ASSESSMENT REPORT

Dongwha Timbers MP 07_0161 MOD 2 Section 75W Modification

Figure 4: Approved site layout of facilities including the location of the proposed wood-fired boiler, and timber stockpiles

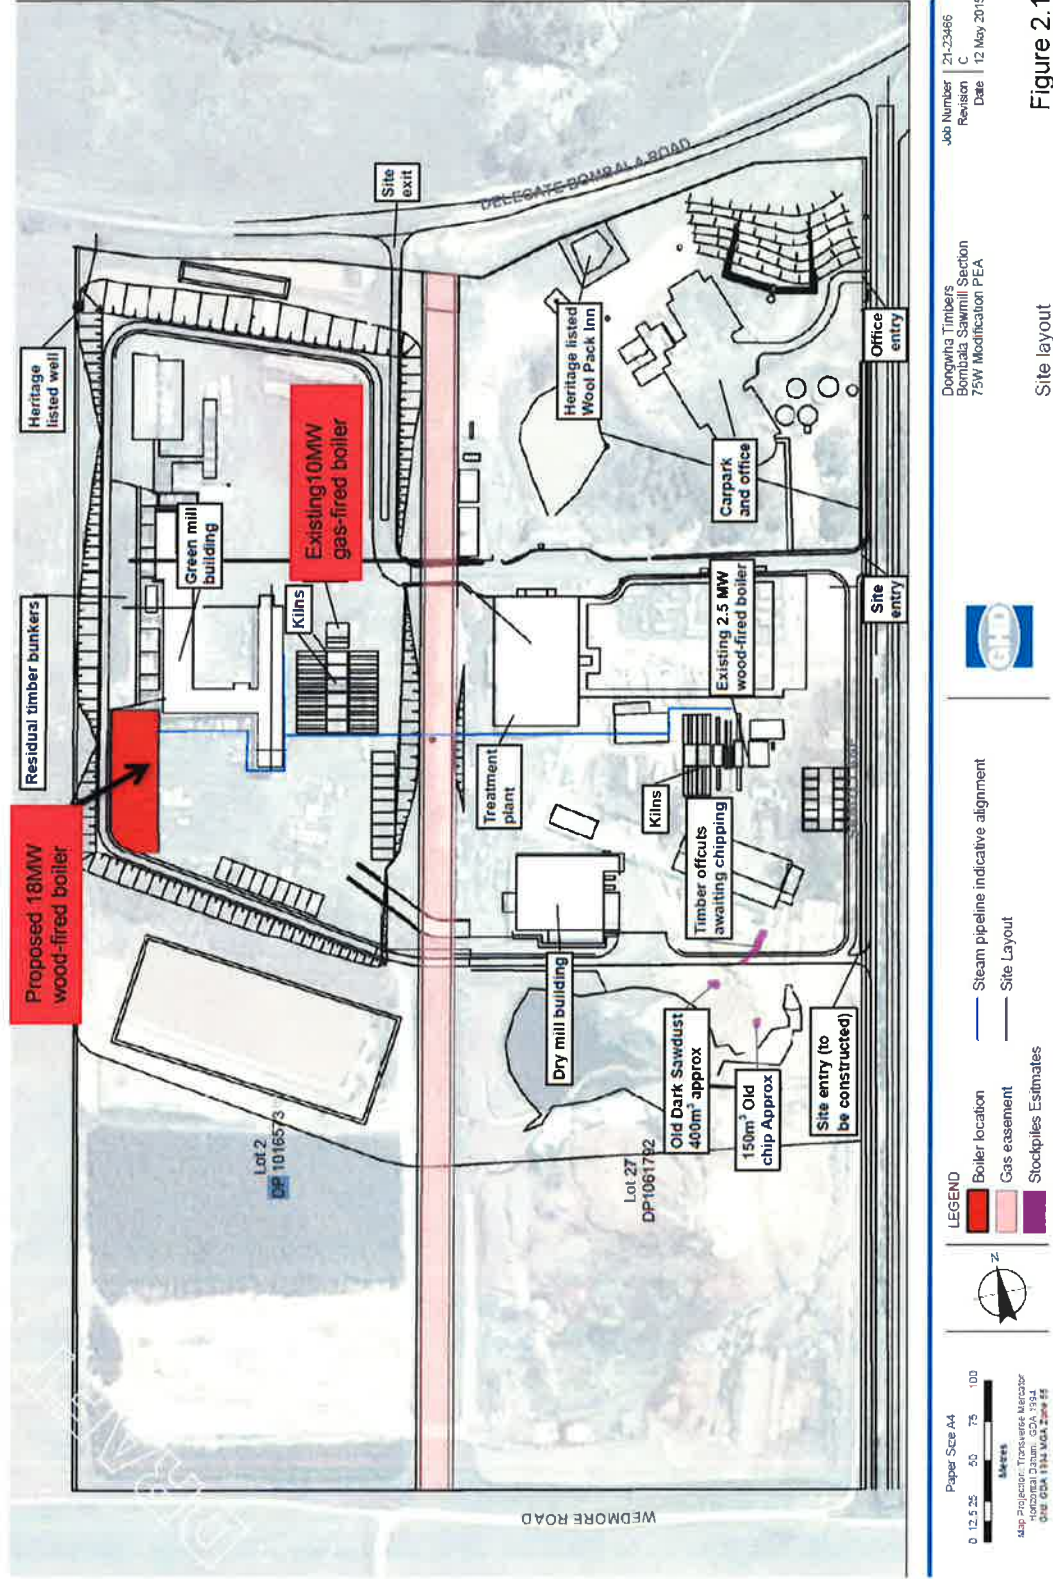
The proposed fuel source(s) for the new 18MW wood-fired boiler would be timber by-products from milling operations that are currently stockpiled on site. The proposed boiler would be located in close proximity to residual timber bunkers on existing hardstand as shown on **Figures 3 and 4**.
